**BRIDGE DESIGN MEMORANDUM – DM0209**

**RE:** Steel H-Pile Anchorage Detail  
Figure 19.2-2 of the *SCDOT Bridge Design Manual*

## Steel H-Pile Anchorage Detail

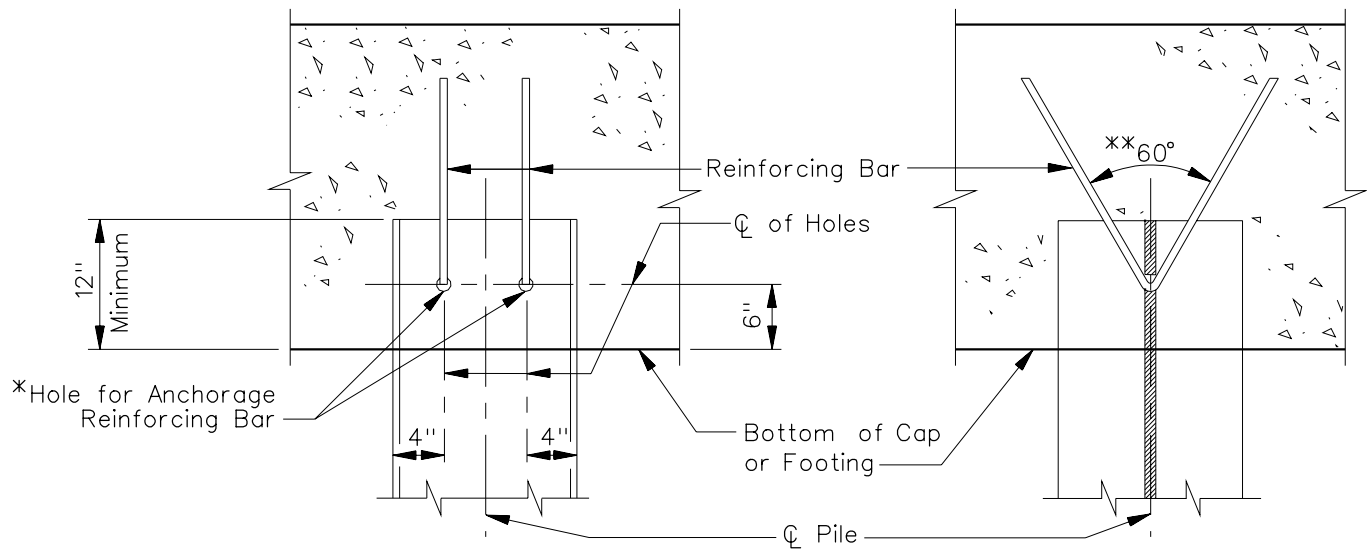
Figure 19.2-2 of the *SCDOT Bridge Design Manual* shall be deleted and replaced with the attached detail. The revised detail allows the Contractor the option to either drill or flame cut the anchorage holes. To provide a construction tolerance for the holes, the designer must specify a minimum and maximum hole size.

A minimum of two #6 (#19) bars shall be used for the anchorage. The maximum hole size should be limited to two times the diameter of the bar and the minimum hole size should be ¼" larger than the bar diameter. The reinforcing bar must be detailed with sufficient length to fully develop the bar beyond the bottom mat of the footing or bent cap reinforcement.

Note: Drill or flame cut the holes. Grind area around flame cut holes to remove burrs. Tie or wedge tightly the reinforcing bar against the top of the hole.

\* Designer to specify a minimum and maximum allowable hole diameter. The minimum diameter should be  $\frac{1}{4}$ " larger than the reinforcing bar diameter and the maximum diameter should be two times the bar diameter.

\*\* Preferred angle is  $60^\circ$  - If necessary, Designer may adjust angle to allow for development length of the reinforcing bar.
